OCONEE

**February 2002
WRITTEN EXAM**

**UTILITY
COMMENTS**
**WITH SUPPORTING
DOCUMENTATION**

QUESTIONS REPORT
for 2002-301 COMBINED UTILITY COMMENTS R1

Enclosure 13.12
Unit 1 Cycle 20
Loop ΔT Vs. Reactor Power

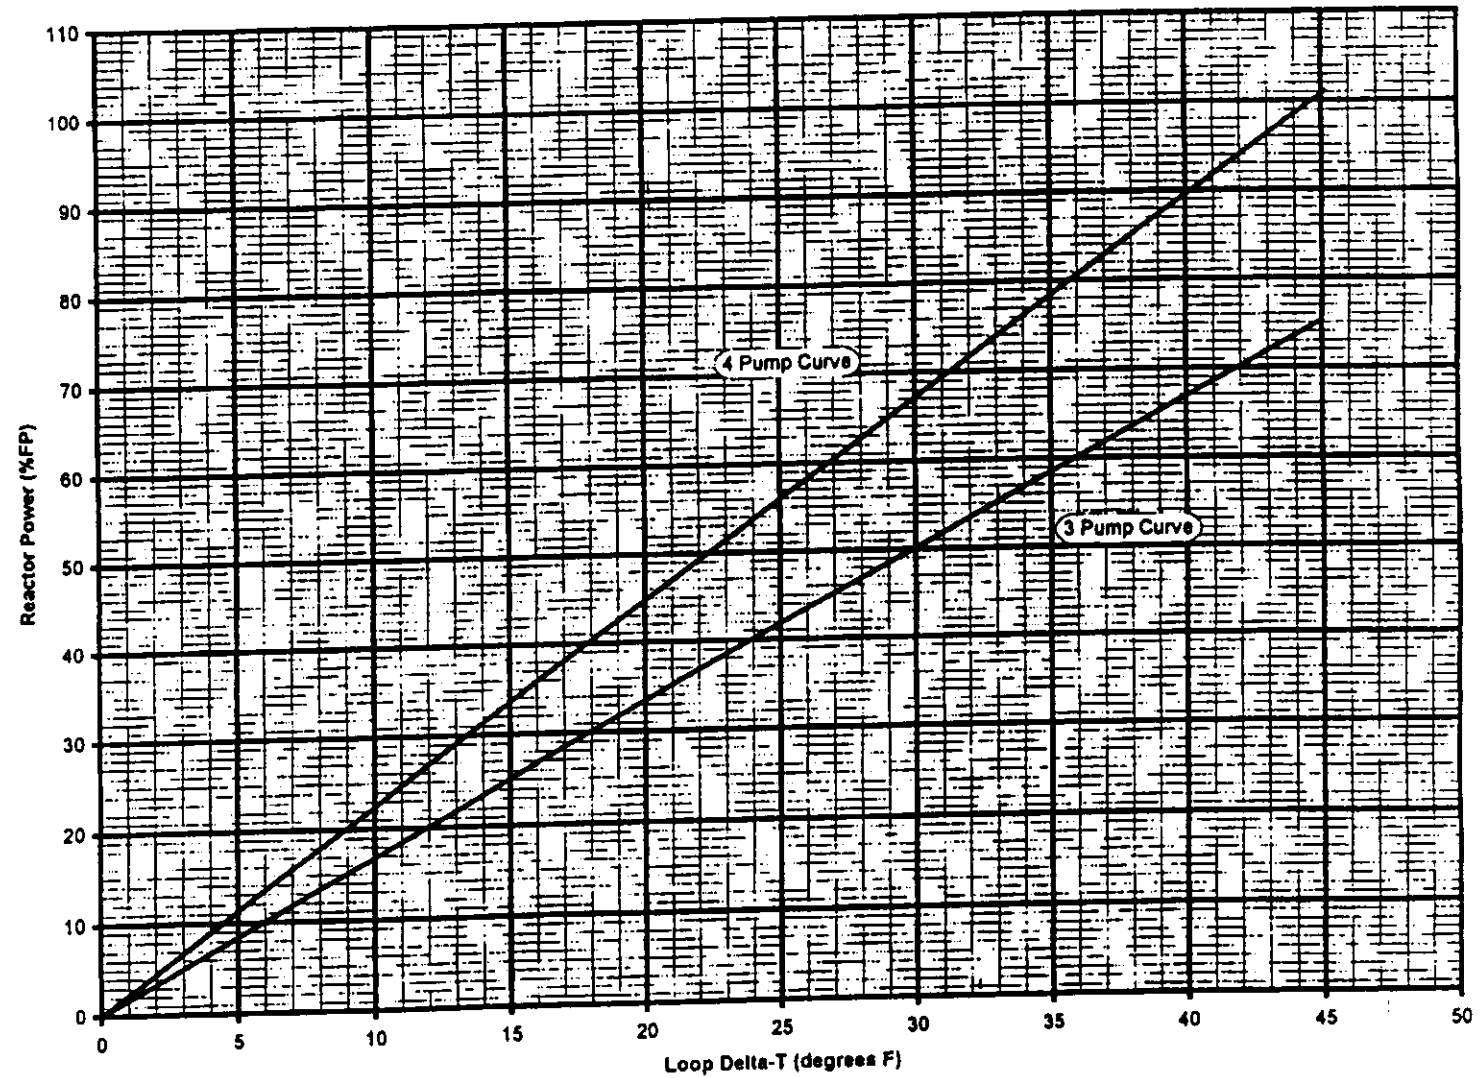
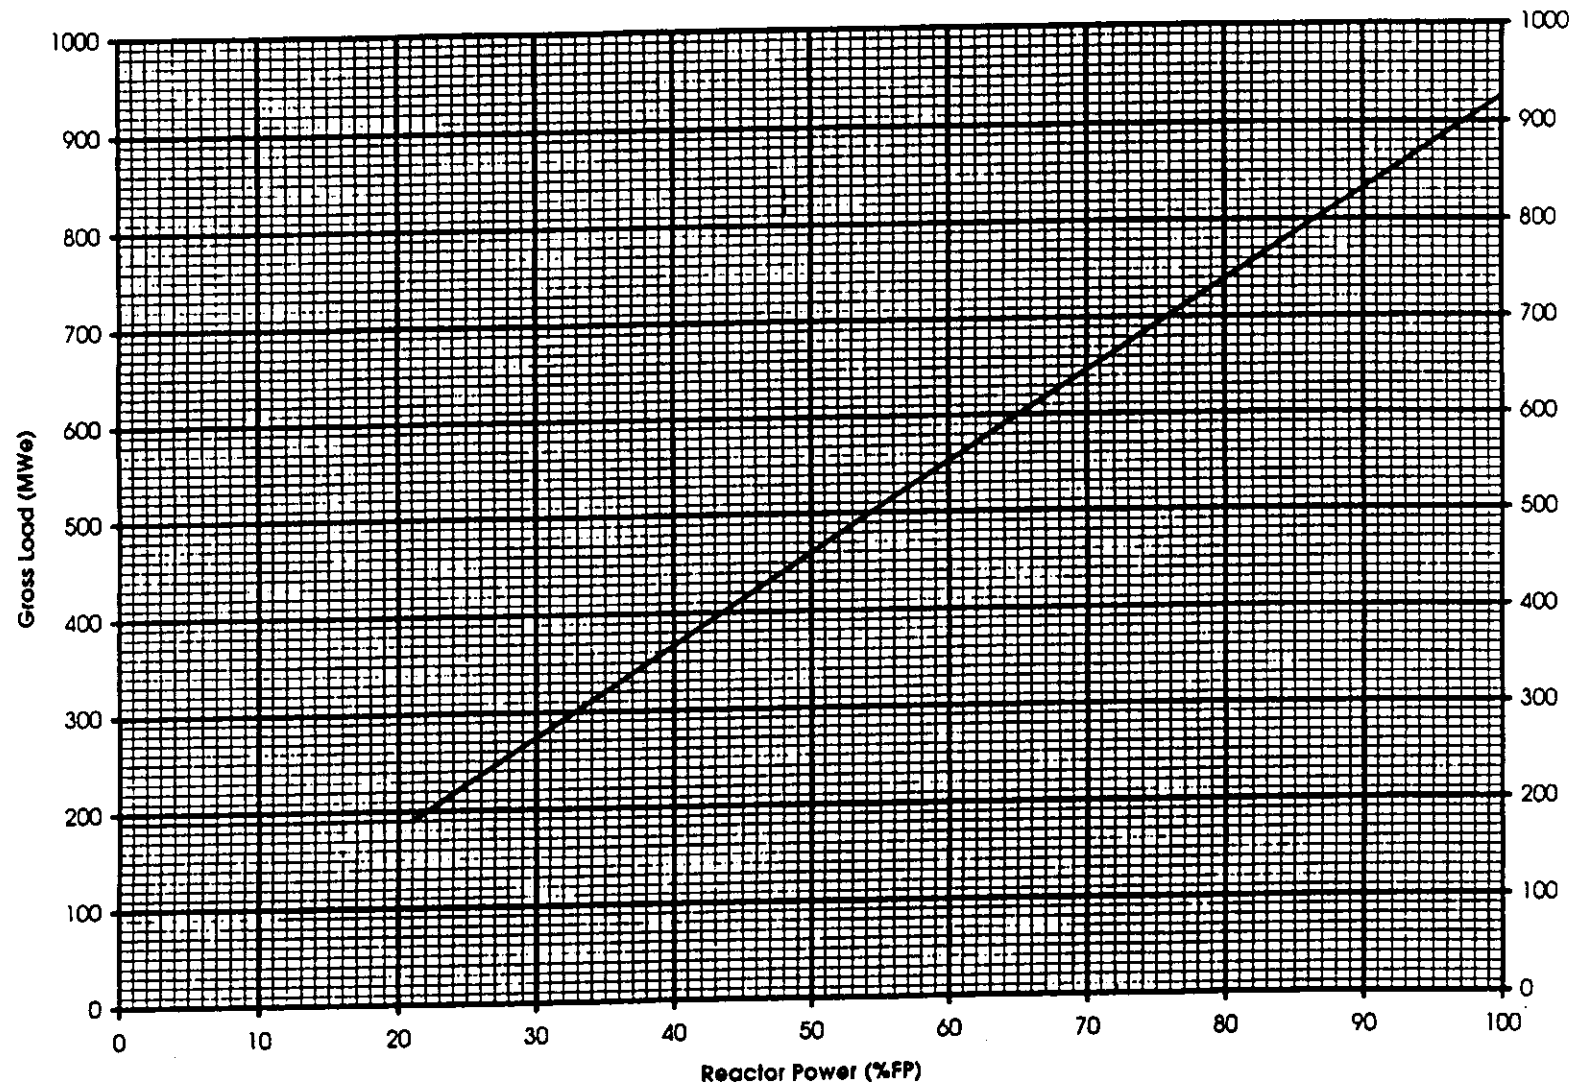
Question originally written using 2544 as MWth. Changed to 2568 per ONS 100% thermal rating.

ONS operators will utilize PT/600/001, Periodic Instrument Surveillance to verify reactor power.

Added attachments encl.13.12, Loop deltaT vs. Rx Power and encl.13.13, Gross Load vs. Rx Power.
Added Mwe value of 320 to stem.
